## Technical Note

Project No: ITL16195  
Project Title: Broadwater Gardens  
Title: HCC Highways Response  
Ref: NM/MD/ITL16195-007  
Date: 19 February 2021

1.2 Hertfordshire County Council (HCC), as the local highway authority, published a response to the application dated 10 February 2021. In their response they have requested further information and details on a number of points, namely relating to the proposed site access junction. Further, initial comments were provided via WHBC that required undertaking a Stage 1 Road Safety Audit (RSA) at the site access junction. This was produced and submitted, alongside a Designer’s Response, to HCC dated 29 January 2021 (report ref: ITL16195-006).

DRAWN: JMc	CHECKED: MD	APPROVED: NM
PROJECT No: ITL16195	SCALE @ A3: 1:250	DATE: 16.02.21
DRAWING No: ITL16195-GA-014		REV: A

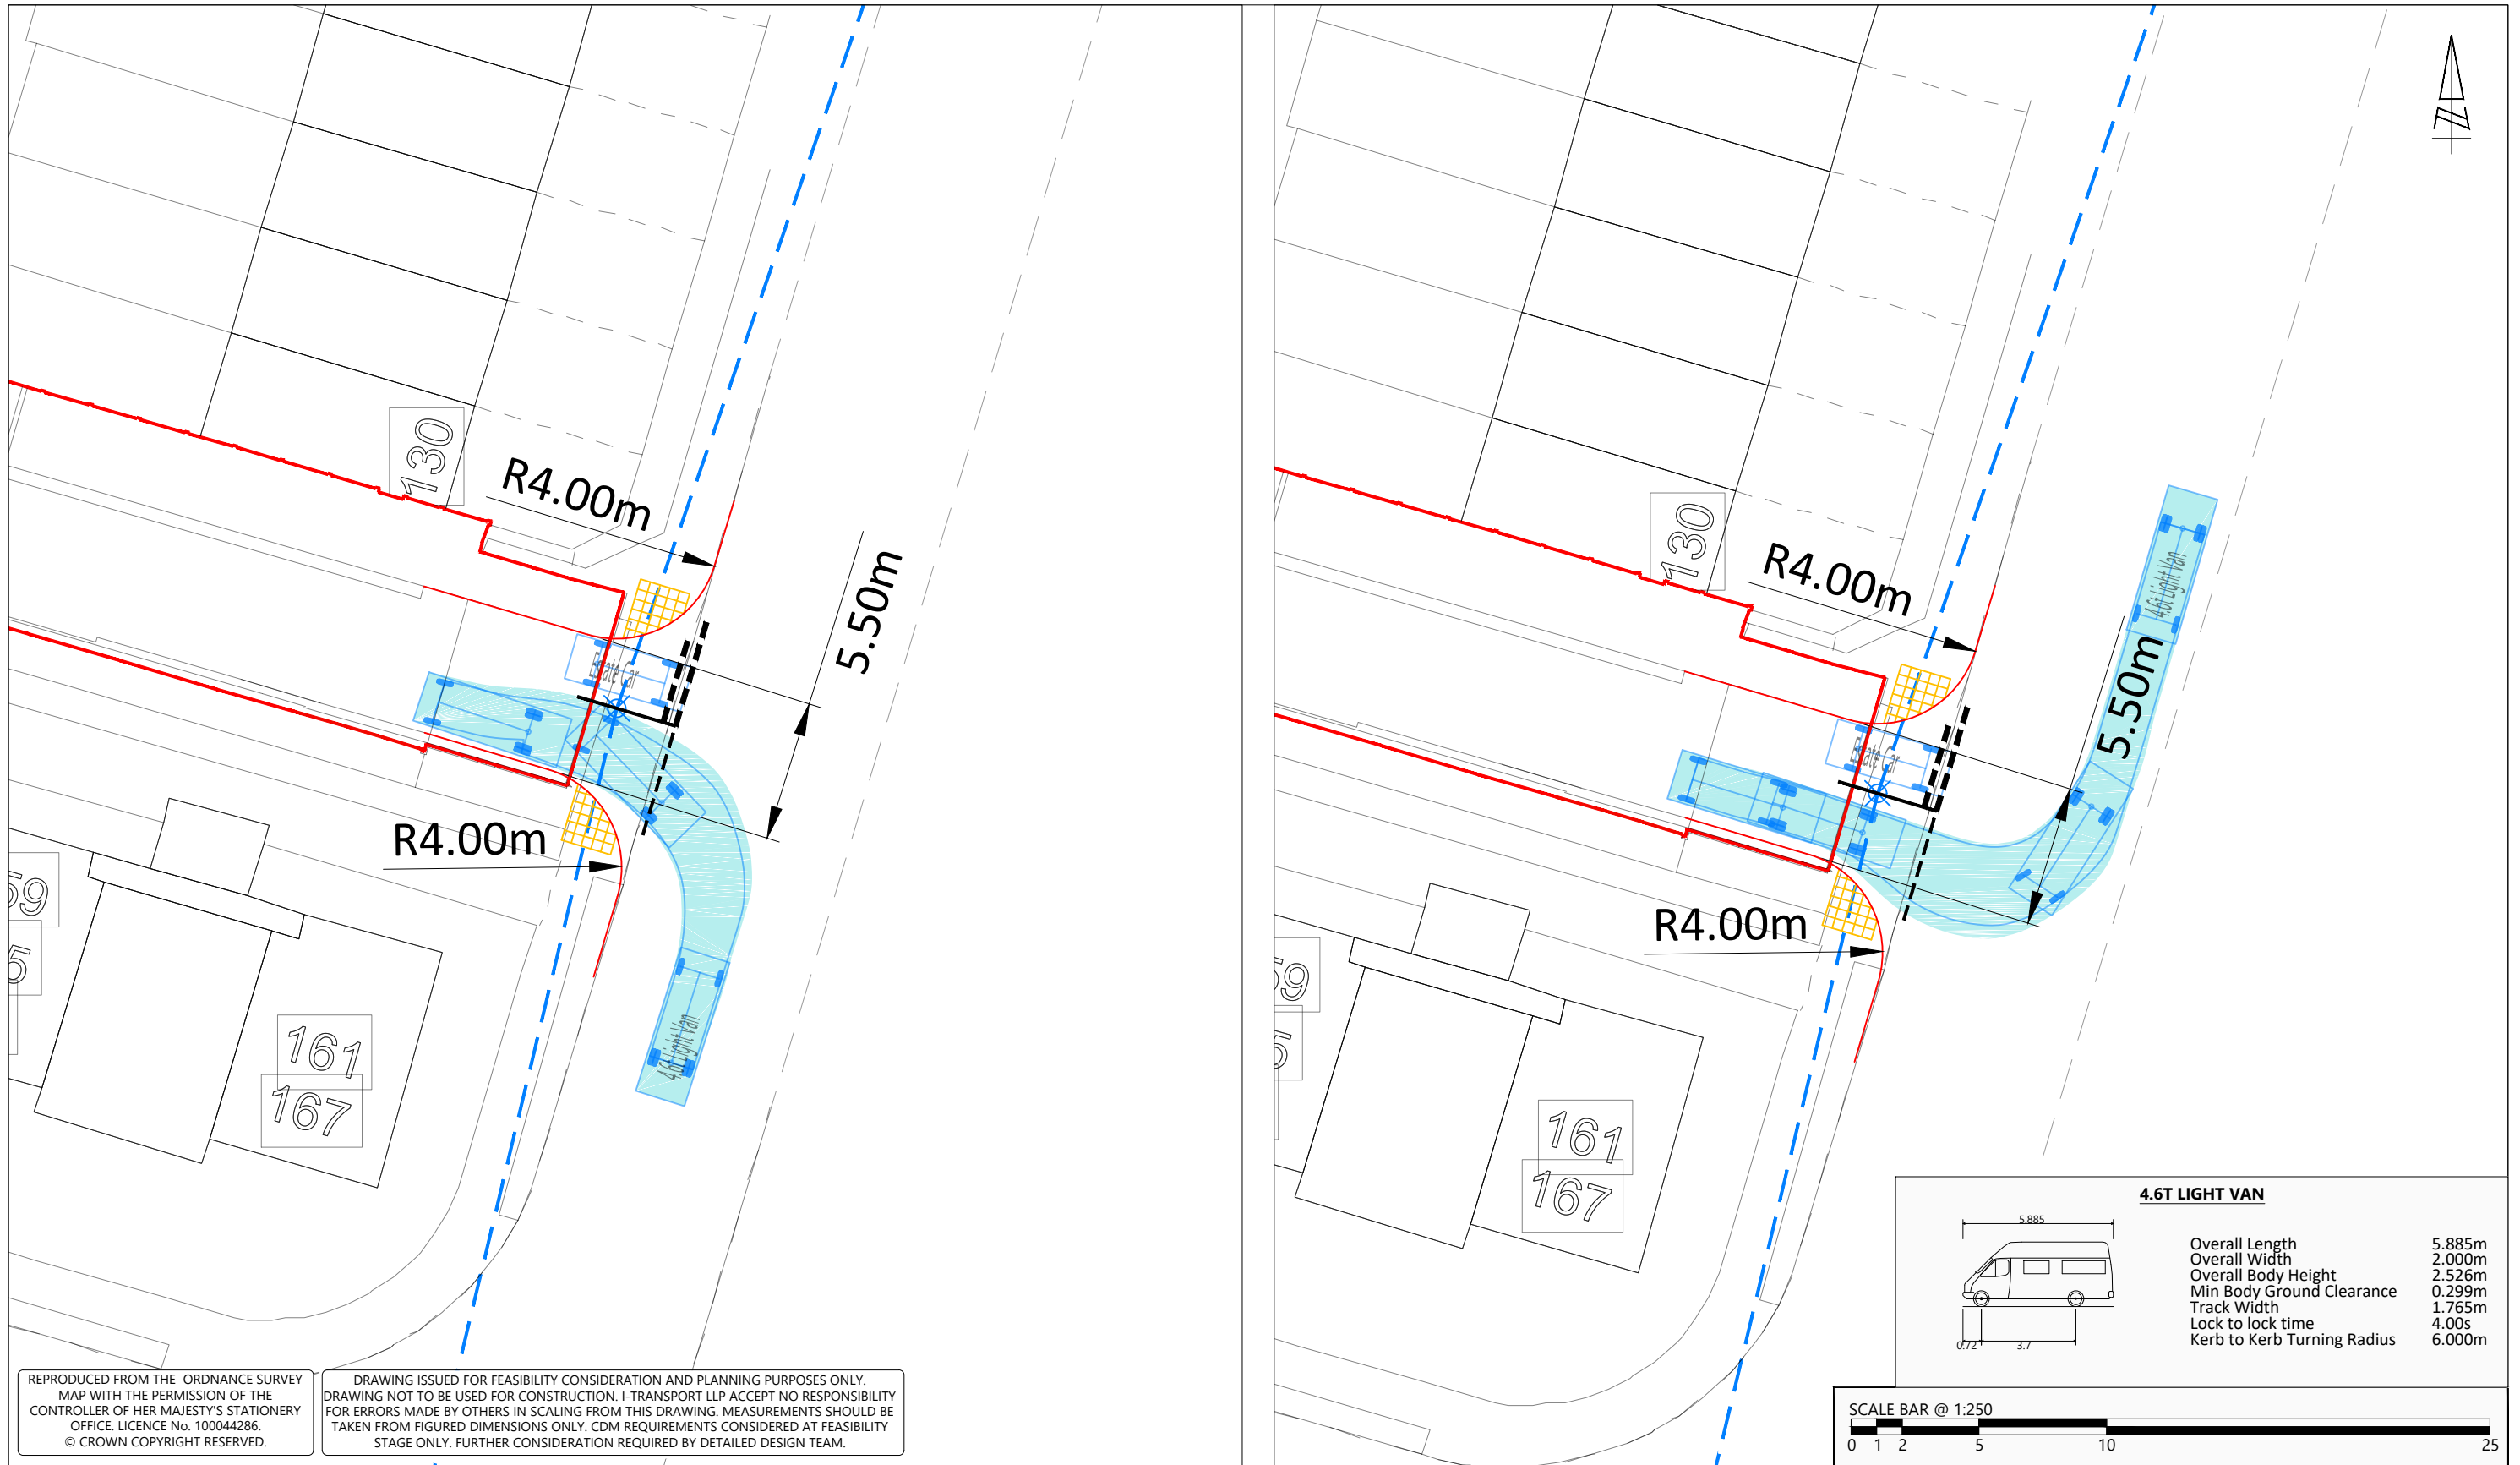
*“It is requested that additional drawings are submitted that shows a box van (typical of online grocery deliveries and servicing vehicles) on a left-turn and also a right-turn into the site whilst a car is positioned at the give-way line.”*

1.7.2 The swept path analysis of this vehicle at the site access, alongside a vehicle at the give way, is shown in Drawing No. ITL16195-GA-014A.

1.7.3 The drawing demonstrates sufficient width to allow for such vehicles to pass a car at the give way.
